14208
19 June 2014

**SECTION 75W MODIFICATION MP11_0082
3 MURRAY ROSE AVENUE, SYDNEY OLYMPIC PARK**

Figure 2 – 3D view of the Chase stairs and fire exit

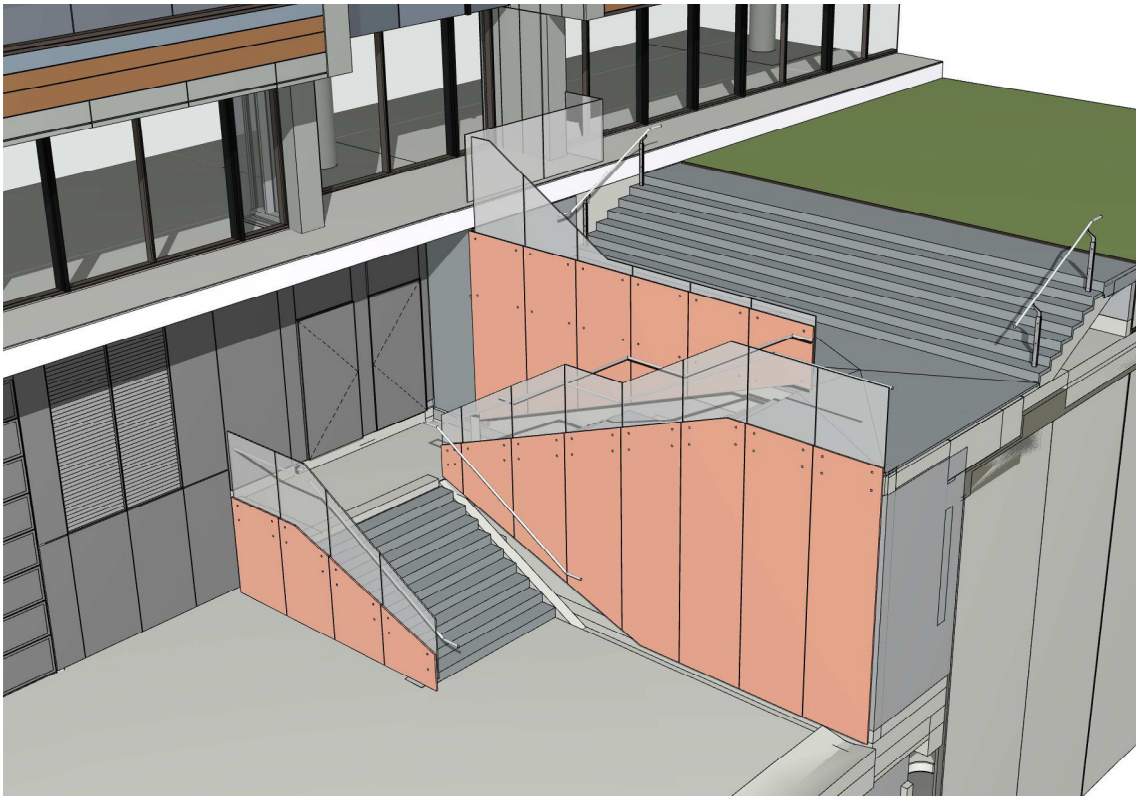
The development of the Chase as approved on the stamped plans would require a significant re-design of the stairs in order to comply with Condition B4 as currently worded. Accordingly, it is considered that the Guidelines should not be implemented as mandatory rules and the wording changes proposed reflect this.

It is not envisaged that people will enter 3 Murray Rose Avenue from the Chase, only an emergency fire exit is proposed, as illustrated in **Figure 2** below. The Chase is also not envisaged as a 'principal footpath' which would cater for a large number of people, given it is partly a loading dock. Therefore, it is considered that access can be provided from Murray Rose Avenue to Brick Pit Park for people with a disability without them needing to use the Chase.

- B4. The building and landscaping, ~~including paths within “the Chase”~~, must be designed and constructed **generally** to provide access and facilities for people with a disability in accordance with the Building Code of Australia and SOPA Access Guidelines 2011. ***Compliance with the SOPA Access Guidelines is not applicable to “the Chase” portion of the site.***
